**AGENDA**  
Regular Hybrid Meeting  
Town of Granby  
Inland Wetlands and Watercourses Commission  
Wednesday, April 9, 2025, at 7:00 pm  
Town Hall Meeting Room

**MEETING MINUTES**  
Town of Granby  
Inland Wetlands and Watercourses Commission  
Wednesday, March 12, 2025, at 7:00 pm

**RE: 188 Day Street Plans**

Re: Review of March 28, 2025 Brook Crossing Plan and Alternatives Analysis Statement  
15 Peck Orchard Road, Granby, CT  
JE Project No. 21-29

Sheet  
GR-1

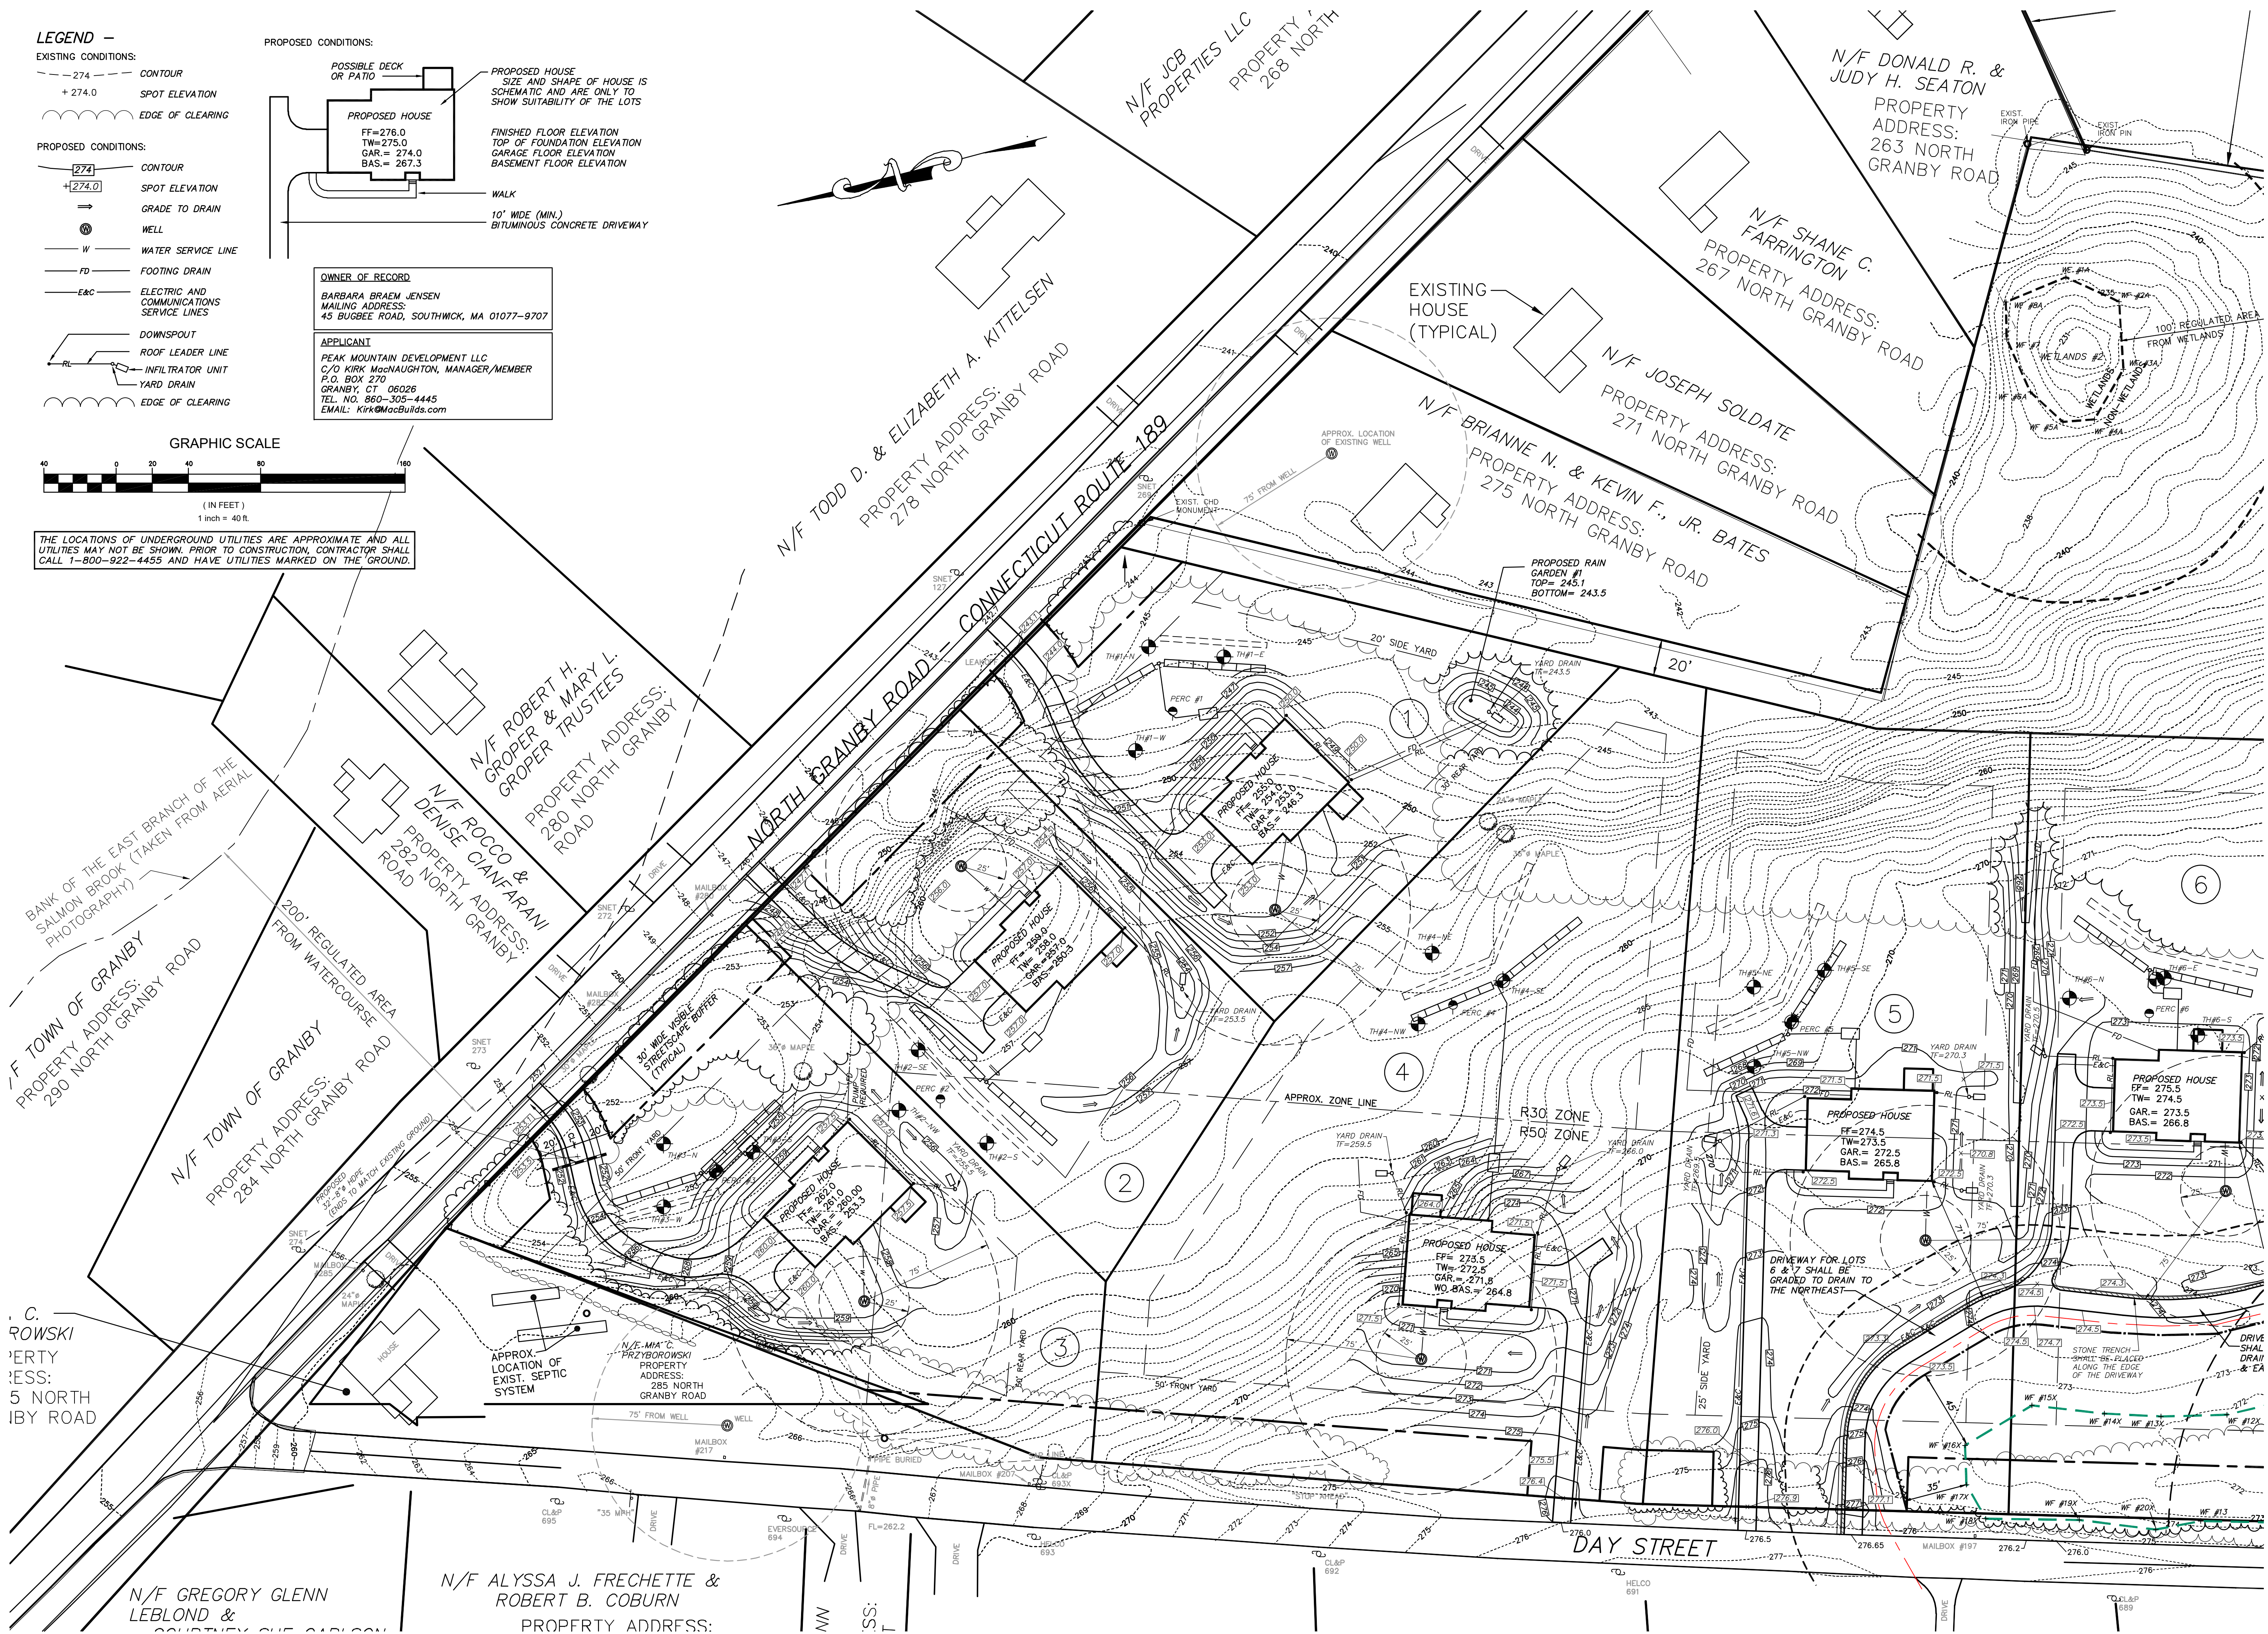
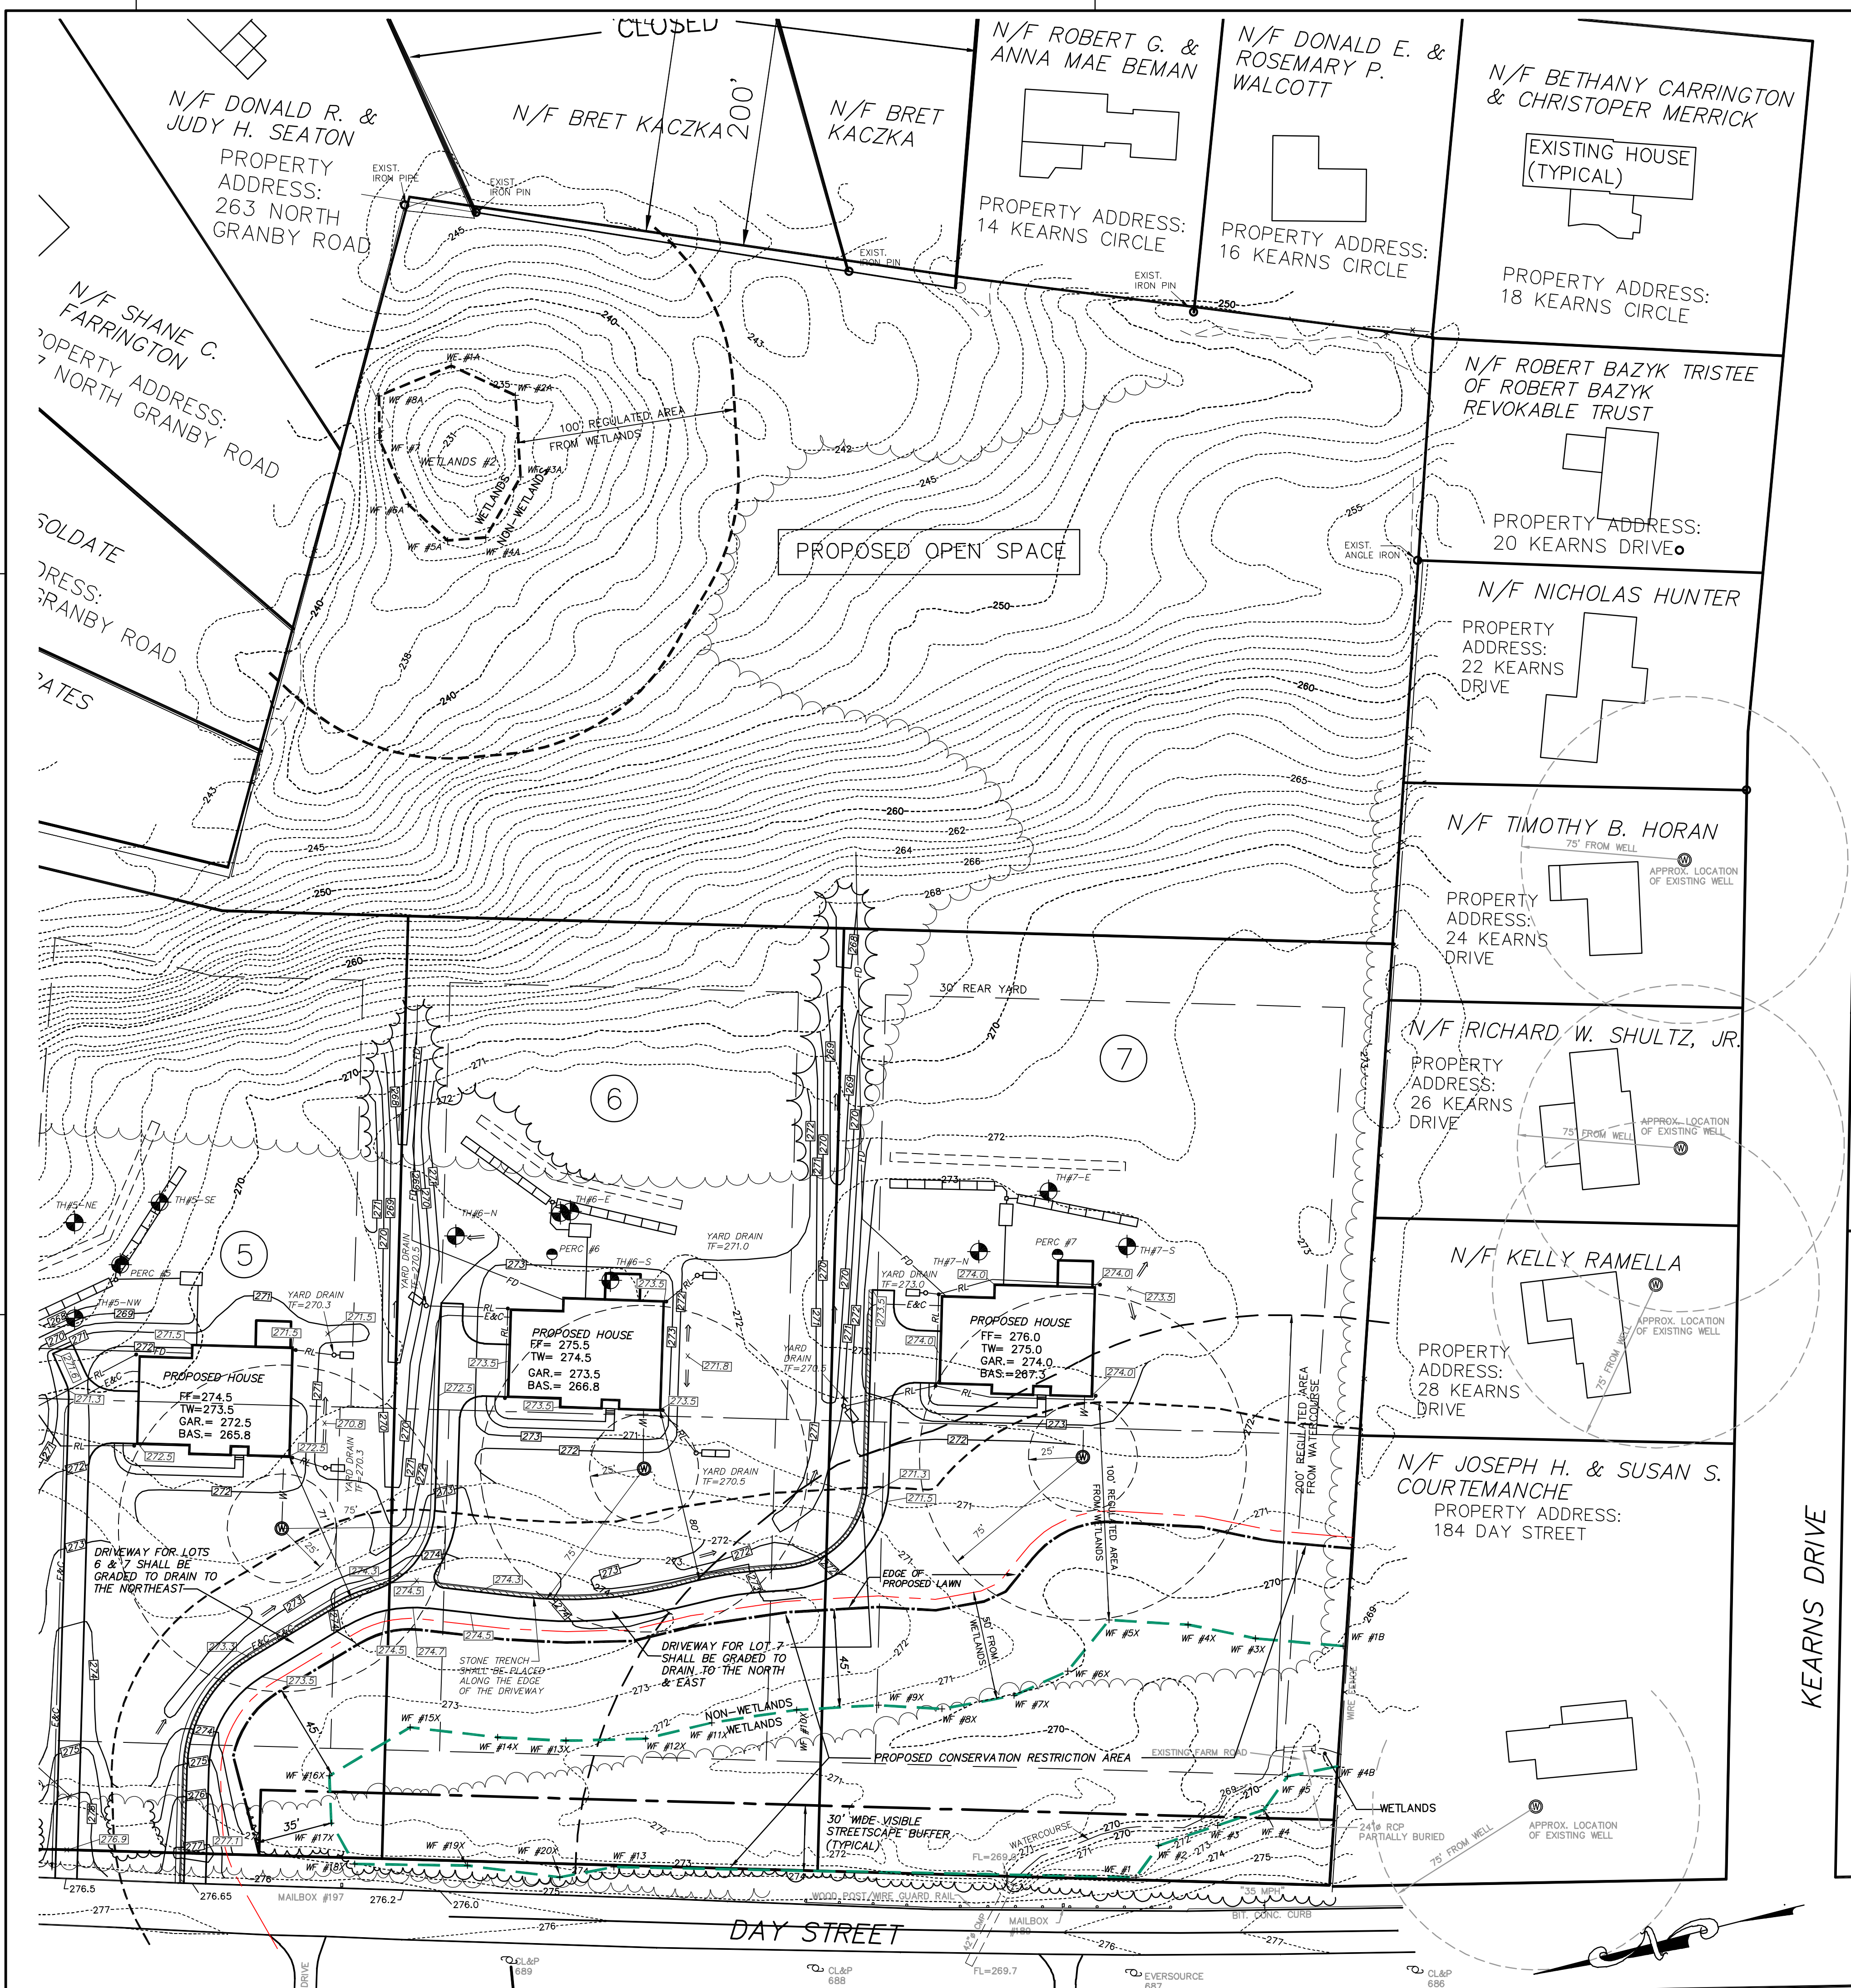
Comment 1                    The total amount of the disturbed area is a required part of the erosion and sediment control narrative and should be on the plan.  
Comments 2-6                The property lines shown are not clear and there is no technical information while the plan is certified as an A-2 survey. If is not an A-2 survey, then that certification should be removed. Because any decision by the Wetlands Commission applies to the property, then the property lines must be clearly shown and any discrepancies removed or clarified.  
Comment 8                  Drainage easement not shown. As this is within the regulated area it should be shown.  
Comment 11                 The flooding limit should be shown on the design plans and ultimately the subdivision plan.

Attached are the revised plan Kirk submitted this morning. I told Kirk I would pass them on to you for review. He is copied on this email.
